TOWN OF CORTLANDT PLANNING BOARD

MEETING AGENDA.....<u>PLANNING BOARD</u> <u>TOWN OF CORTLANDT</u> <u>6:30 THURSDAY EVENING*</u> NOVEMBER 7, 2024

Attention:Mr. Chris Kehoe, AICP, Director- Department of Planning & Community
DevelopmentRegarding:Proposed Self Storage Facility
3 Locust Avenue
Cortlandt Manor, NY 10567
Section 34.5, Block 2, Lot 6
PB-2024-1Mr. Kehoe,

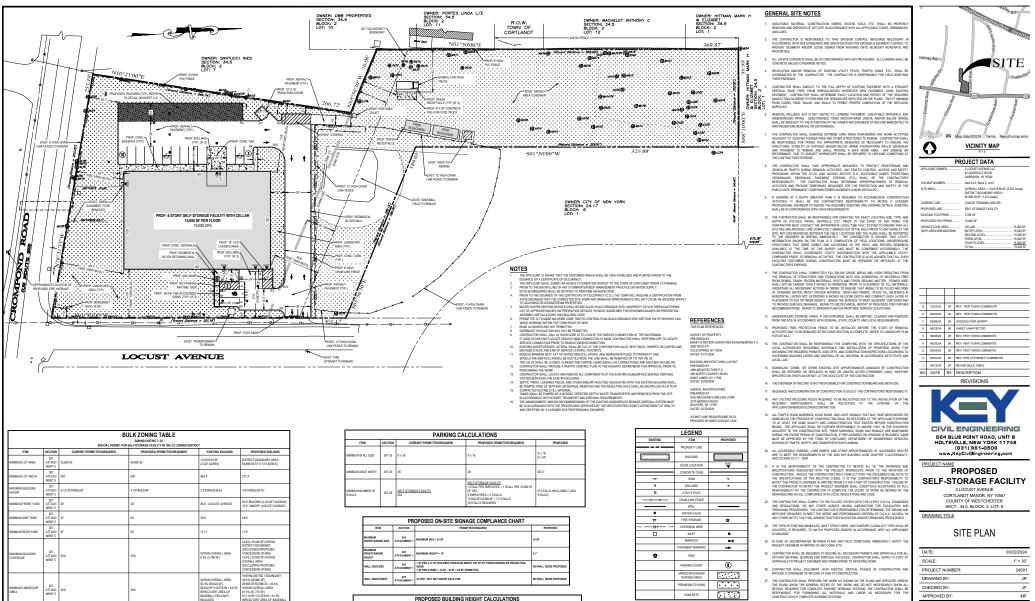
- A. The rear lot's southerly curbline was shifted north by approximately 18 feet, resulting in the loss of two parking stalls. The landscape area on the south side of the rear parking lot has increased.
- B. The elevation at the north end of the rear parking lot was raised by approximately 1 foot.
- C. The elevation at the south end of the rear parking lot was raised by approximately 1.5 feet.

D. The grade at the southeast corner of the proposed building was raised by approximately 18 inches.

Due to the revised grades surrounding the building and the physical reduction (see following Architectural Revisions) in the building structure, the proposed building height is now calculated at 34.97'. This is 3.03' reduction in the overall proposed height, from what was previously submitted to the Town.

EXTERIOR ELEVATIONS

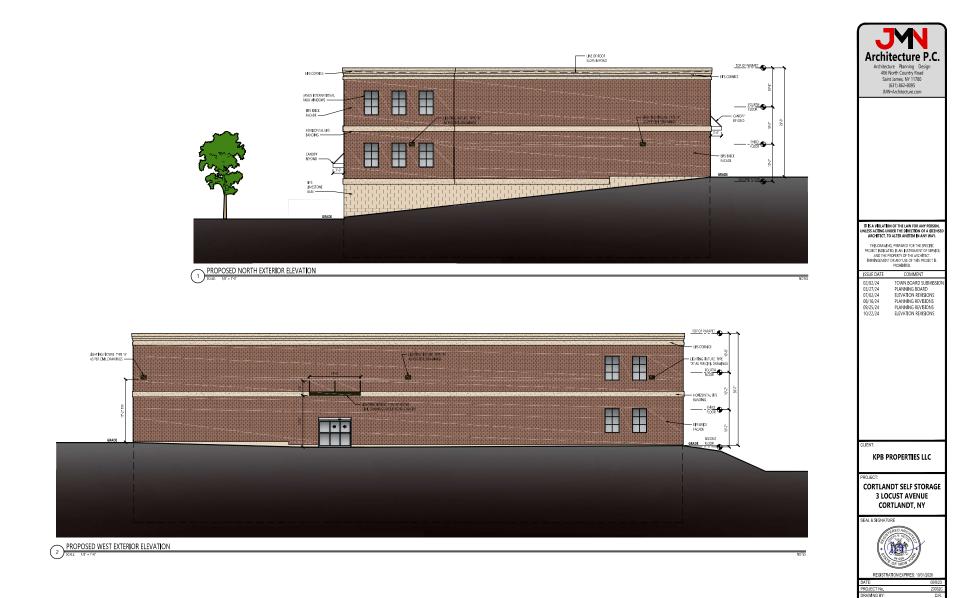
- A. Reduced the building's height by 2.4 feet.
- B. Revised the roof pitch to provide for internal rood drains instead of scuppers and leaders.
- C. Adjusted the grade around the building per revised civil drawings (see above Site Changes).
- D. Revised the visual appearance of the building to read as a two-story building by reducing the number of faux glazing and horizontal bands. These modifications made the new design more harmonious in character and scale with the existing school building.

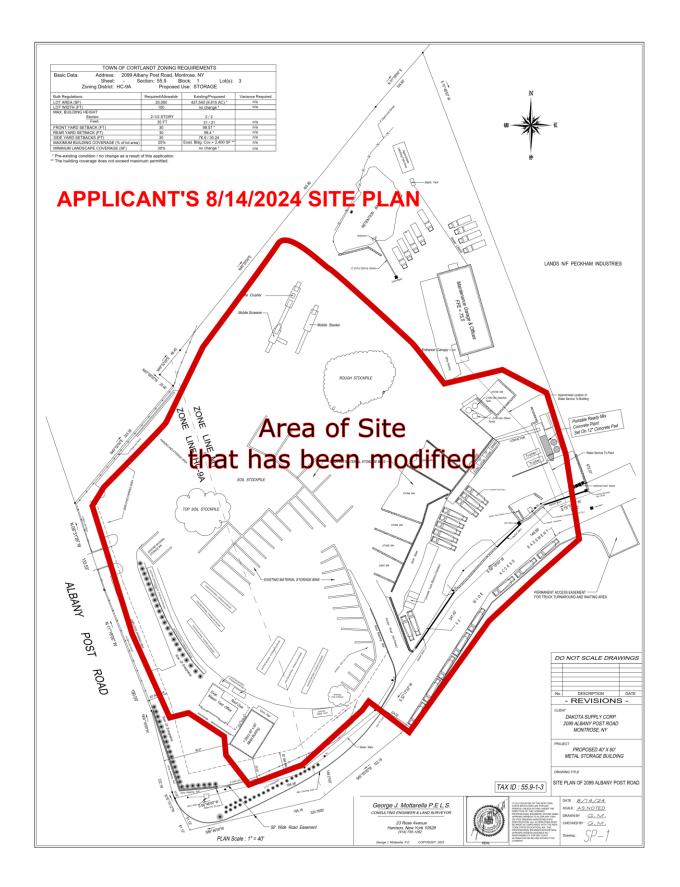
The Site Plan submitted to your Board (8/14/2024, enclosed) for your approval is bare and needs to show the required Site Plan information. The Site Plan now indicates new, **unapproved** uses and elements that must be newly approved throughout the site.

Further, the Planning Board has yet to affirmatively waive any Site Plan requirements, and no petition has been made to waive any requirements; therefore, all the zoning code requirements are appropriate to show on the Site Plan.

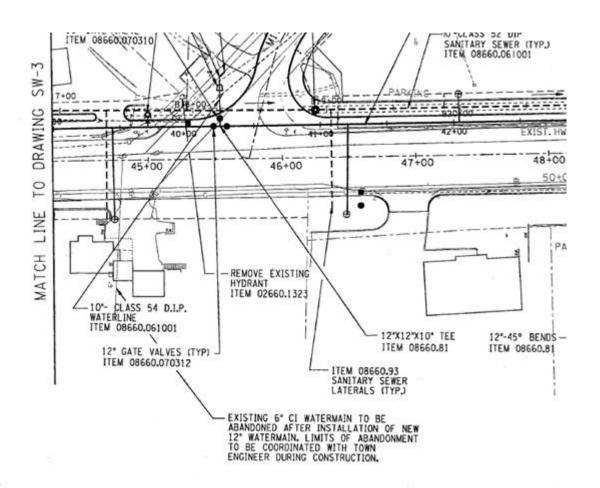
- 1. Subject parcel is in the Cortlandt Boulevard West Sewer Improvement Area. Applicant is advised that sanitary sewer charges are based on water consumption. Activities that use excess water such as vehicle washing or said uses that create fats, oils and greases are subject to additional charges. Benefit unit assessment rolls are annually by the Town Board in December.

- 2. Investigate and identify where the existing on-site drainage discharges too.
- 3. This office requested details of the oil/water separator and calculations for its sizing. Additionally, please provide details of the entire collection system and recycling system (if applicable).
